APPLICATION NO.	FILING DATE	FIRST NAMED INVENTOR	ATTORNEY DOCKET NO.	CONFIRMATION NO.	
10/564,196	06/20/2006	Craig Rochford	66455-264-7	7497	
25269 7590 09/25/2007 DYKEMA GOSSETT PLLC			EXAM	EXAMINER	
FRANKLIN SO	QUARE, THIRD FLOO	SOON, SHELD	SOON, SHELDON STEWART		
1300 I STREET, NW WASHINGTON, DC 20005			ART UNIT	PAPER NUMBER	
			2841		
	·				
		•	MAIL DATE	DELIVERY MODE	
			09/25/2007	PAPER

Application No.	Applicant(s)			
	10/564,196	ROCHFORD ET AL.			
Office Action Summary	Examiner	Art Unit			
	Sheldon S. Soon	2841			
The MAILING DATE of this communication app Period for Reply	ears on the cover sheet with the c	orrespondence address			
A SHORTENED STATUTORY PERIOD FOR REPLY WHICHEVER IS LONGER, FROM THE MAILING DA - Extensions of time may be available under the provisions of 37 CFR 1.13 after SIX (6) MONTHS from the mailing date of this communication. - If NO period for reply is specified above, the maximum statutory period w - Failure to reply within the set or extended period for reply will, by statute, Any reply received by the Office later than three months after the mailing earned patent term adjustment. See 37 CFR 1.704(b).	ATE OF THIS COMMUNICATION 16(a). In no event, h

Figure 4 from Kauhaiemi

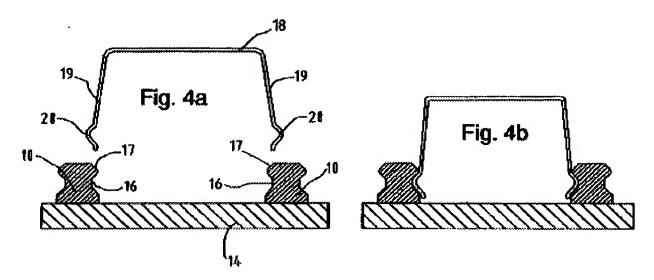
Regarding claim 1 – Kauhaiemi discloses the following elements of the instant invention: a PCB (item 14) and a component (item 18) mounted thereon, wherein the PCB and component are releasably secured to one another by securing means (items 10 and 28), the securing means comprising a resiliently flexible and sprung biased clip (item 28) member secured to the component; and at least one slug (item 10) secured to the PCB and being originally discrete from the PCB and the component, but fails to disclose the component comprises an aperture for receiving a slug, and wherein the clip member is arranged to abut the slug received by the aperture. Shlyakhtichman teaches the use of a shield assembly with spring fingers (items 58 A) that receive the attachments means on the inner portion of the fingers, thus creating the aperture inside. It would have been obvious to someone skilled in the art at the time of the invention to use the spring fingers of Shlyakhtichman on the metallic shield of Kauhaiemi since placing the attachment means under the metallic shield will protect the attachment means being fouled from foreign particles and grime as well as protecting them from getting caught or torn off

Figure 1 from Shlyakhtichman

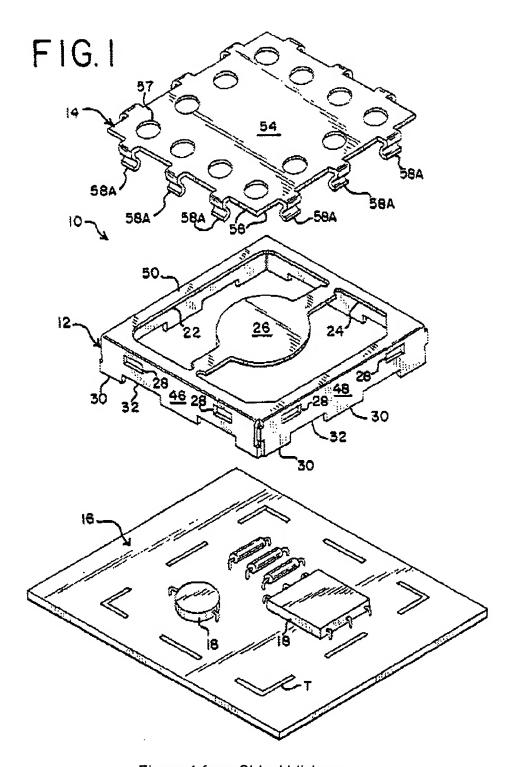
Regarding claim 7 - Kauhaiemi in view of Shlyakhtichman discloses all the elements of claim 6 of the instant invention but fails to disclose the clip members are located substantially opposite one another so that the spring bias of each clip member acts generally in the direction of the other clip member. Shlyakhtichman teaches the use of a shield assembly with spring fingers (items 58 A) that receive the attachments means on the inside and act with a force inwards, towards the opposite finger. It would have been obvious to someone skilled in the art at the time of the invention to use the spring fingers of Shlyakhtichman on the metallic shield of Kauhaiemi since placing the attachment means under the metallic shield will protect the attachment means being fouled from foreign particles and grime as well as protecting them from getting caught or torn off.
